# Agenda Item # 6

## SUB-003212-2025

Resubdivision of Mobile Civic Center Subdivision

APPLICATION NUMBER 6 DATE February 20, 2025

# DETAIL SITE PLAN

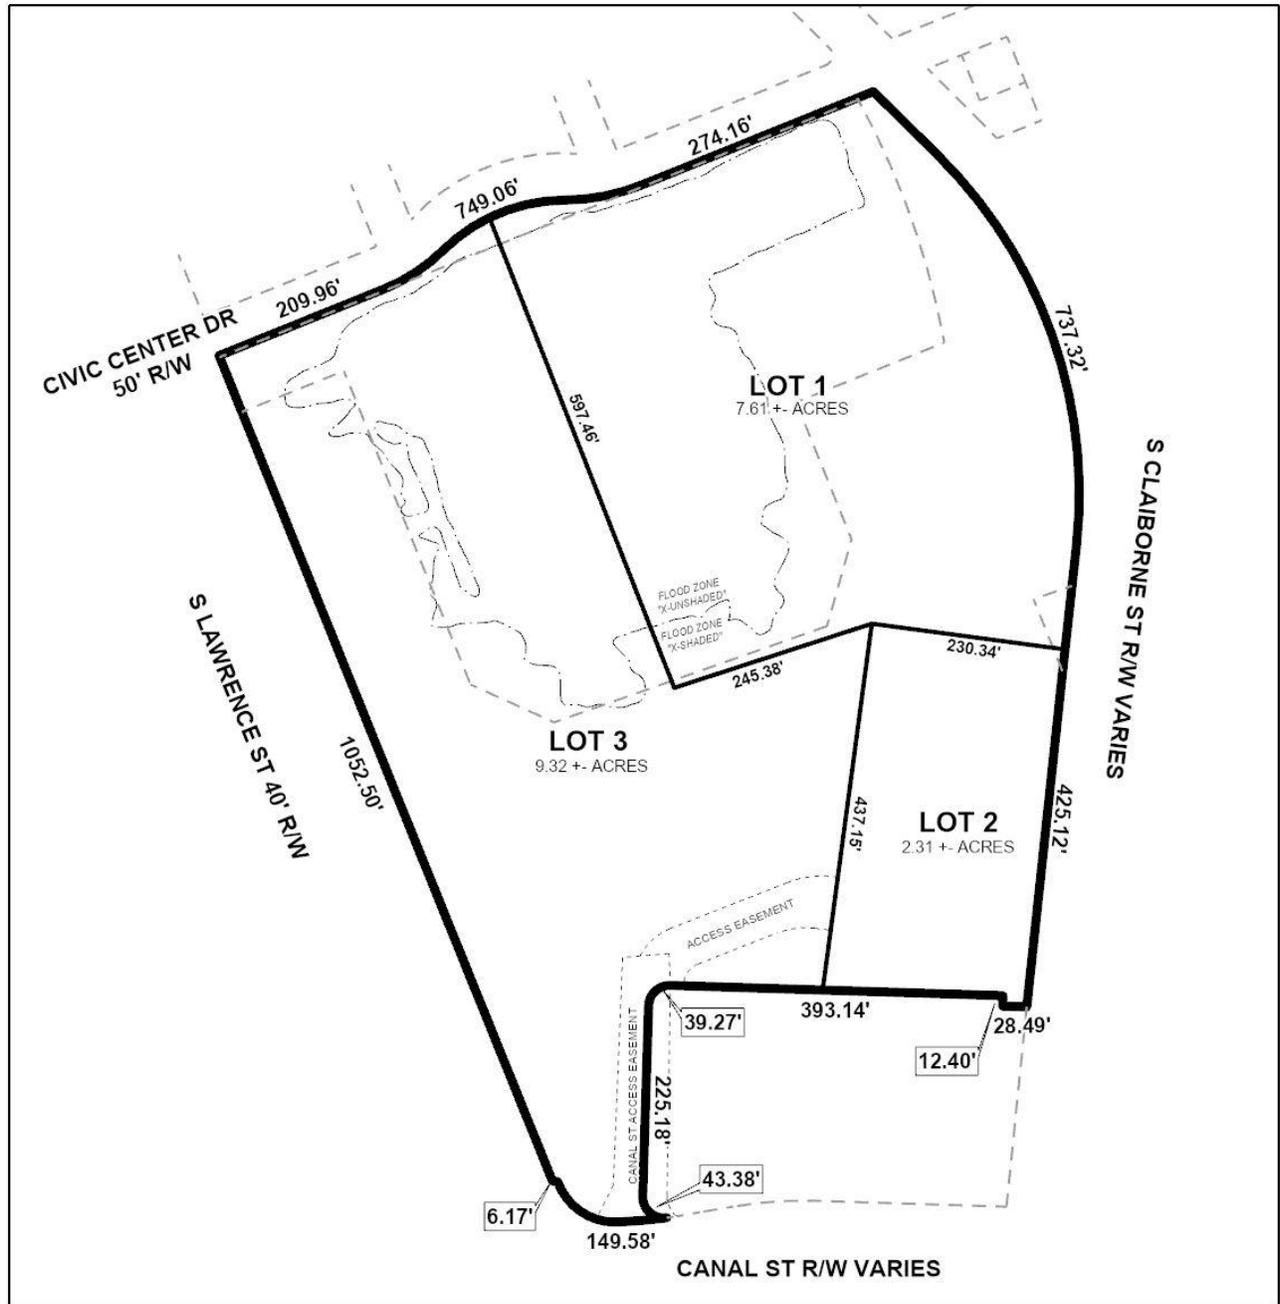
The proposed lots front Civic Center Drive, South Lawrence Street, Canal Street, South Claiborne Street, and South Jackson Street. Canal Street, is a minor arterial street on the Major Street Plan, and as such should have a right-of-way of 120-feet. The preliminary plat submitted states that the right-of-way varies along Canal Street, therefore, if approved, the Final Plat should depict the minimum existing right-of-way to the centerline (or entire width), providing dedication, if necessary. Civic Center Drive is a minor street, with curb and gutter, and a compliant right-of-way of 50-feet, making no dedications necessary. South Lawrence Street is a minor street with curb and gutter, and an existing right-of-way of 40-feet; however, previous Subdivisions along the street, have allowed for the existing right-of-way width to be maintained, therefore a waiver of Section 6.B.9. of the Subdivision Regulations may be appropriate, if approved. South Jackson Street and South Claiborne Street are major collector streets with curb and gutter, and are depicted as having a variable rights-of-way. If approved, the Final Plat should be revised to depict a minimum of 25-feet from the centerline, or provide dedication. If deemed necessary by the Engineering Department, dedication of curb radii at the corner of Civic Center Drive and South Lawrence Street, per Section 6.C.6. of the Subdivision Regulations, should be provided, if approved.

The subject site is within the Downtown Development District (DDD), which has property standards based upon zoning classification. The site is zoned T-3 and T-5.2. Newly platted lots in T-3 sub-districts along the East side of Lawrence Street between Civic Center Drive and Canal Street are required to have street frontage between 30-feet and 120-feet along their primary frontage. Newly platted lots in T-5.2 sub-districts are required to have street frontage between 14-feet and 180-feet along their primary frontage. As proposed, all three (3) lots exceed 180-feet of street frontage along their primary frontage, making a waiver of Section 9.F.4.(b) of the Subdivision Regulation necessary, if approved.

As proposed, Lot 3 will be split-zoned as both T-3 and T-5.2. However, as the property is owned by the City of Mobile, it is exempt from the requirements of the Unified Development Code (UDC), and can be approved without the need for rezoning at this time. Therefore, if the Subdivision application is approved, a waiver of Section 6.A.1.(a). of the Subdivision Regulations will be required. It should be noted that at such a time as the property is sold, it will need to be rezoned to a single zoning classification prior to the development of the land. Both proposed Lots 1 and 2 will be entirely zoned T-5.2.

Properties located within a T-3 along the East side of Lawrence Street between Civic Center Drive and Canal Street and properties located within a T-5.2 sub-district are allowed a 12-foot maximum setback along street frontages. Furthermore, properties located within a T-3 along the East side of Lawrence Street between Civic Center Drive and Canal Street have a five (5)-foot minimum setback along secondary frontage. If approved, the maximum and minimum setback lines should be illustrated on the Final Plat.

The preliminary plat provides the proposed lot size in square feet and acres. If approved, this information should be placed on the Final Plat or a table should be furnished on the Final Plat providing the same information.

Proposed Lot 3 has existing access easements. If approved, a note should be placed on the Final Plat stating that no structures are allowed in any easements without the permission of the easement holder.

1. Revision of the plat to depict the existing minimum right-of-way to the centerline of Canal Street (or total right-of-way width), including dedication if necessary, to provide 60-feet from the centerline;

2. Retention of the rights-of-way for South Lawrence Street and Civic Center Drive;
3. Revision of the plat to depict the minimum existing right-of-way to the centerline of South Jackson Street and South Claiborne Street, including dedication if necessary, to provide 25-feet from the centerline;

4. Retention of the lot sizes in both square feet and acres, or the furnishing of a table on the Final Plat providing the same information;
5. Depiction of the 12-foot maximum setback along all street frontages;

6. Depiction of the 5-foot minimum setback for the secondary frontage of the T-3 portions of Lot 3;
7. Placement of a note stating that no structures are allowed in any easements without the permission of the easement holder;
